UNITED STATES
NUCLEAR REGULATORY COMMISSION
WASHINGTON, D. C. 20555

LICENSEE: Duke Power Company
FACILITY: McGuire Nuclear Station, Units 1 and 2
SUBJECT: SUMMARY OF MEETING REGARDING GROUNDWATER MONITORING
AND CONTROL, MCGUIRE NUCLEAR STATION, UNITS 1 AND 2

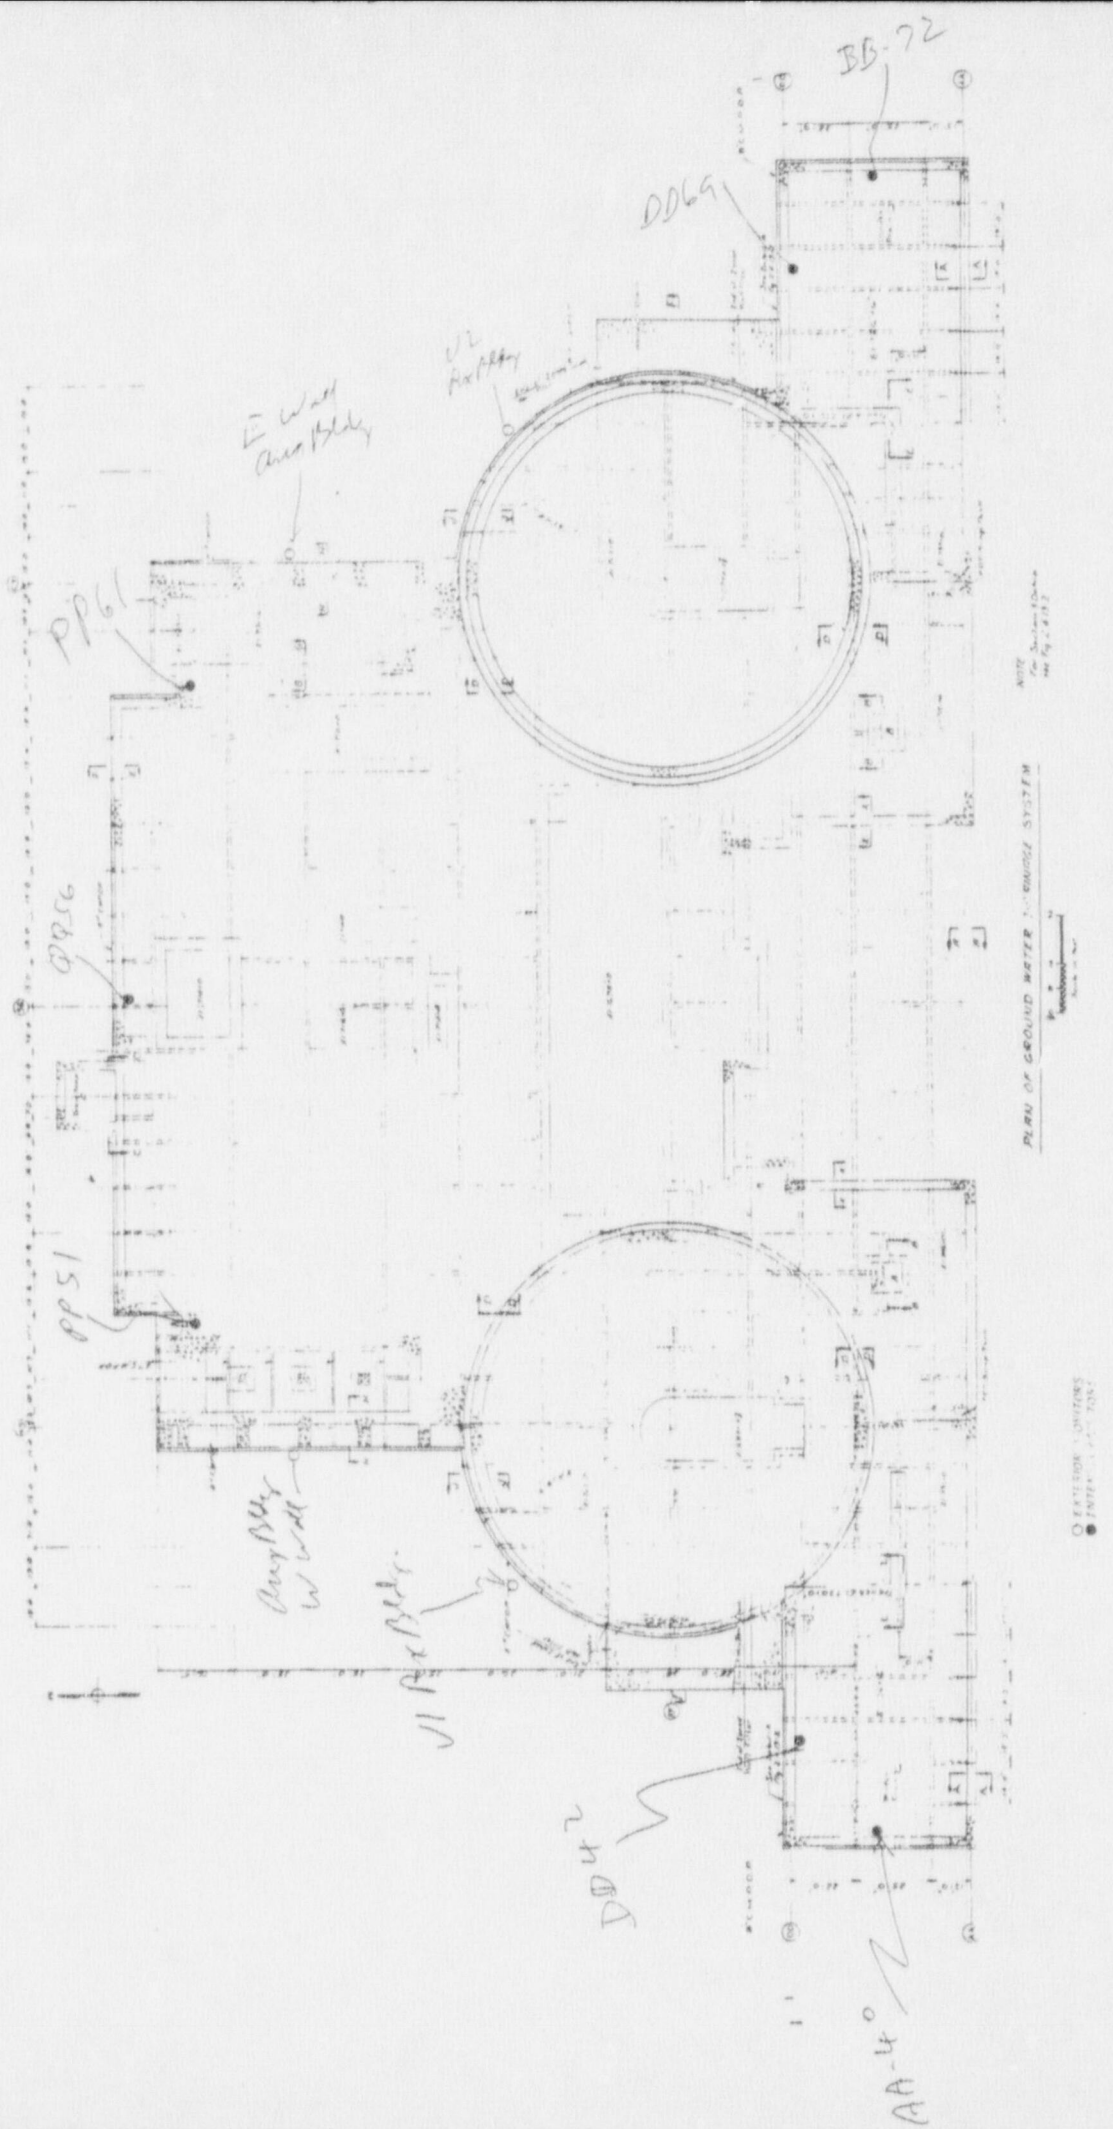
The interior and exterior wells used to monitor groundwater levels were observed. The location of these wells are shown on the attached sketch. The staff also reviewed an example of the recorded data.
